From: Mcconnell, DAVE P <dave.p.mcconnell@lmco.com>
Sent: Tuesday, March 27, 2018 8:56 PM
To: Grant Robinson
Cc: Daryl Dixon; Mrazik, Philip; Thomas Jacobson
Subject: APU Inboard Mount

Case Number: C0091097
Customer: Thai Aviation Services Limited
Aircraft S/N: 920146
Aircraft Model: S-92A
Aircraft TT: 6,125
ATA: 49
Part Number: 92303-02101-043
Case Subject: APU I/B Mount-Pilot Holes Misaligned And Tapered Shims Required

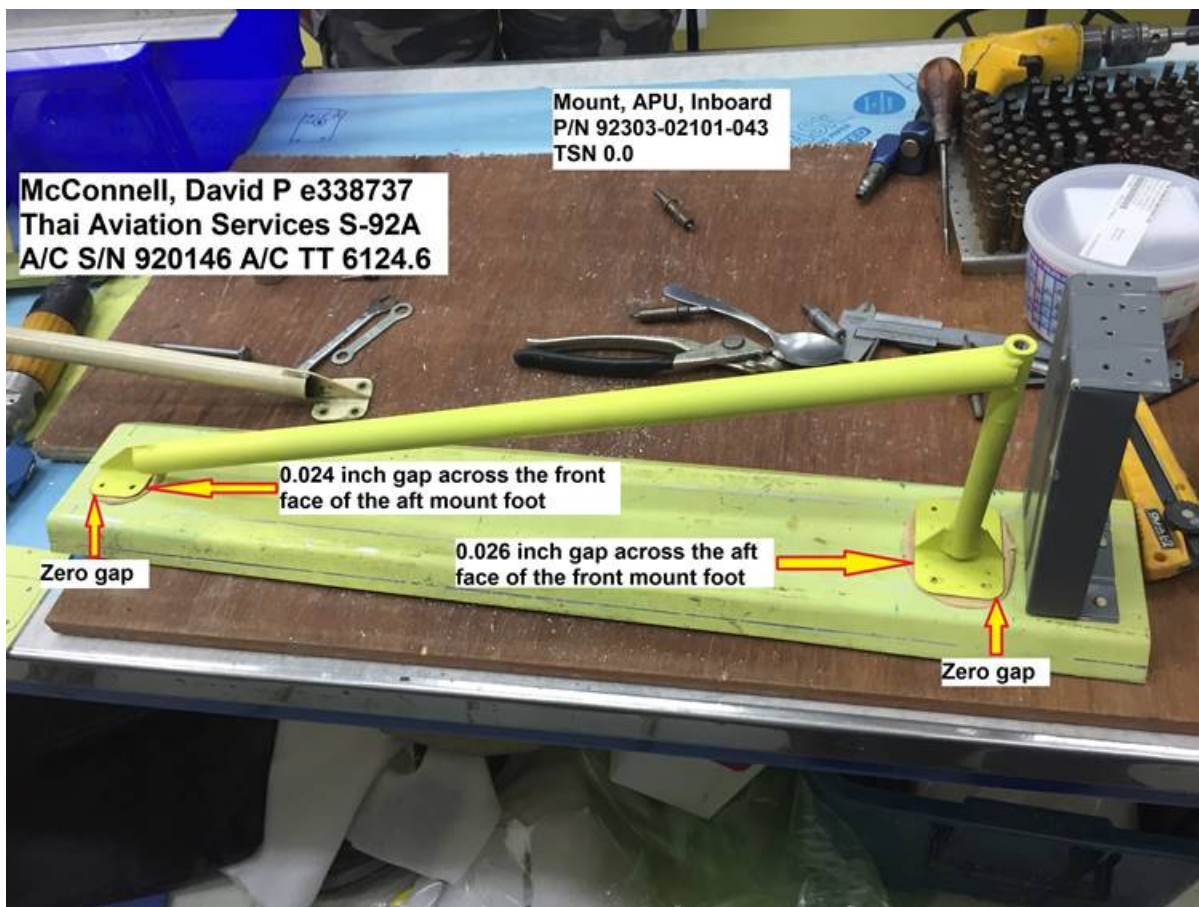
1. The attach bolt pilot holes in the replacement mount forward foot did not fully align with the bolt holes on the airframe. All were out by approximately 1/2D. Opening the holes to -5 Hilok size will not clean up the holes.
2. The mount feet of the replacement mount did not have the same angle as the removed mount. The replacement mount was found to have an 0.024 inch gap along the front edge of the rear mount foot and an 0.026 inch gap along the aft edge of the front mount foot.

1. Pilot holes mislocated – Add doublers to the forward mount foot plate upper surface, one on each side. The doublers will be made from 0.050 in. thick 301 ¼ hard stainless, or 4130 steel fabricated by cutting off the mount feet of the unserviceable mount. The doublers will be riveted to the mount foot plate in three places, using countersunk solid rivets with the countersunk head down. Drill mount bolt holes as appropriate.

2. The gaps between the fore and aft mount feet and A/C skin - Fill with tapered shims made from solid Al stock of an appropriate thickness. Fit P/N 92303-02100-107 / -108 shims as necessary to achieve the final mount height of 5.840 as specified in the response to Case C0090343.

All aft pilot
holes line up

Add 0.050 301 1/4 Hard doublers or fabricate
4130 steel doublers from unserviceable mount. 2
places. Attach doublers to mount foot with
countersunk rivets, head down.

Sikorsky Engineering has reviewed the information in this case and has deemed that the customer's suggested repair and shimming is acceptable as long as the non-aligned holes are flush plugged in the repair prior to rework.
